Re: *Estimated Cost of New Renewable and Fossil Generation in California*

CEC-200-2014-003-SD

Re: Southern California Edison Company's Comments on the California Energy
Commission's *Estimated Cost of New Renewable and Fossil Generation in
California*, Publication Number: CEC 200-2014-003-SD

Figure 1

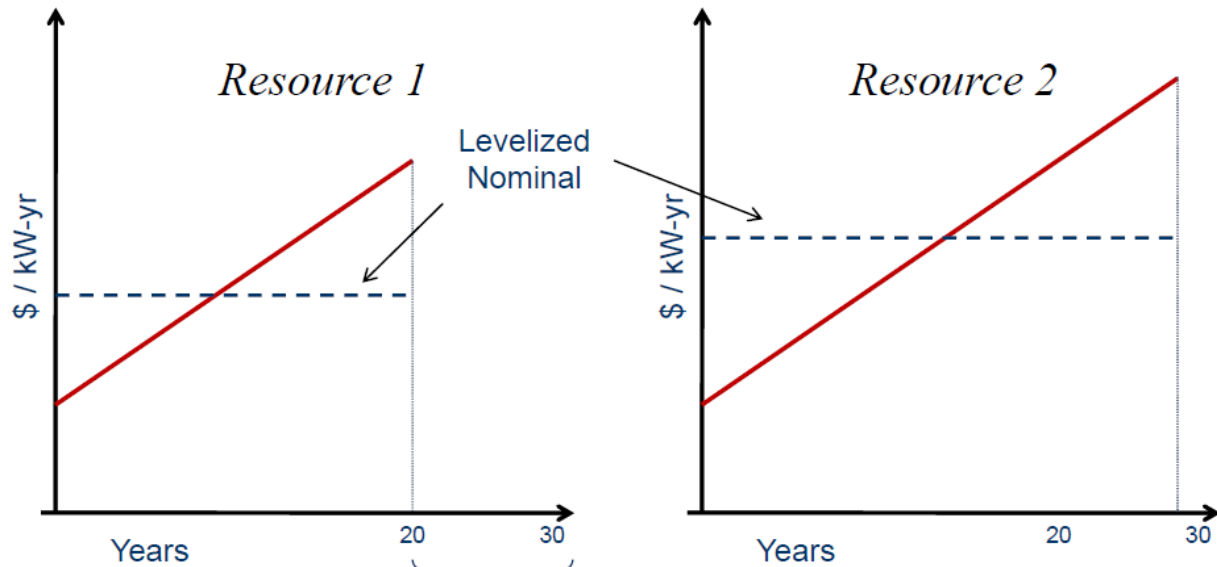
First, compare levelized cost on a real basis. Calculating levelized cost on a nominal basis (i.e. equal values for all years in nominal dollars) will distort reported cost when comparing resources with different asset lives. To illustrate this, consider two resources (see Figure 1) with the same levelized real cost⁵ but differing economic lives. Resource 1 will have a lower levelized nominal value despite providing the same value from year to year as Resource 2. If comparing resources on a levelized nominal basis only, a decision maker will mistakenly believe that Resource 1 is a better value when in fact he or she should be indifferent between the two assets because he or she will have to build a new Resource 1 in year 20. The fundamental issue with levelized nominal values is that they do not consider replacement energy and capacity costs. Two possible solutions are to assume generic replacement energy and capacity cost and evaluate all resources on an equal to time frame or to assume that resources will be replaced with the same resource (see Figure 2). The analysis presented by SCE at the Workshop assumed the latter by calculating a levelized real value (i.e. equal values for all years in constant dollars). Using this metric, resources with differing economic lives can be accurately compared.

Figure 6

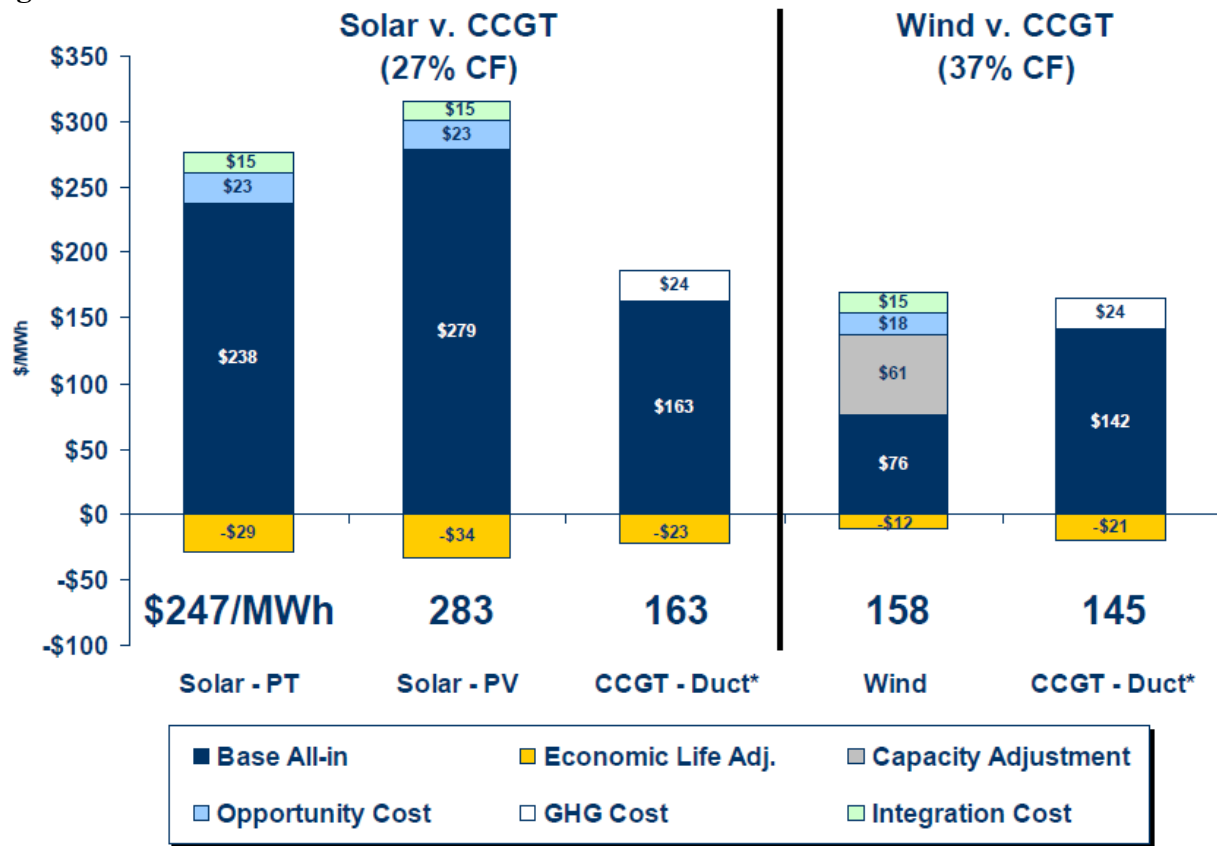
Fourth, the levelized cost of intermittent resources should consider integration costs. Intermittent resources require additional ancillary services in order to ensure that load and generation are always in balance. Figure 6 is an example of how variable wind generation can be throughout a month. This variability requires the procurement of additional regulation, ramping, and following resources for integration. Estimates for these additional costs are very rough and are contingent upon technology, location, and the amount of intermittent resources already on the system. There are a number of public sources for wind integration costs that can be relied upon by the Energy Commission, however. For instance, an evaluation of a Pacific Gas & Electric ("PG&E") renewable integration model conducted by Lawrence Berkeley National Laboratory found scenarios in which the model produced results from \$13 to \$46/MWh. In contrast, the study authors noted outside-of-California analyses generally below \$10/MWh.⁷ SCE's presentation assumed \$15/MWh as an interim value, with the expectation that more refined values will be available in the future.

Finally, the Energy Commission should compare resources on a \$/kW-year basis and using a screening curve that controls for the impact of capacity factor levelized cost. Figure 6 and 7 show the results of the analysis presented by SCE at the workshop and are consistent with each other. Figure 6 shows the \$/MWh impact of each of the four implicit costs noted above as well as an estimate of greenhouse gas emissions compliance costs. Figure 7 shows the same analysis using SCE's recommended screening curve approach. Levelized \$/kW-year is displayed on the y-axis and capacity factor is displayed on the x-axis. Dispatchable resources are represented by a line from zero to one hundred percent capacity factor. Non-dispatchable resources are represented by a single point. This approach more clearly reflects the underlying economics of resource planning. For instance, it is now clear why CTs are often constructed when a resource is only needed to run a few hours out of the year. The cheapest conventional resources create a "screening curve" by which all other resources are benchmarked. Both solar and wind resources should be benchmarked to a CCGT with an equivalent capacity factor according to the screening curve, and both resource technologies are slightly more expensive than a CCGT.
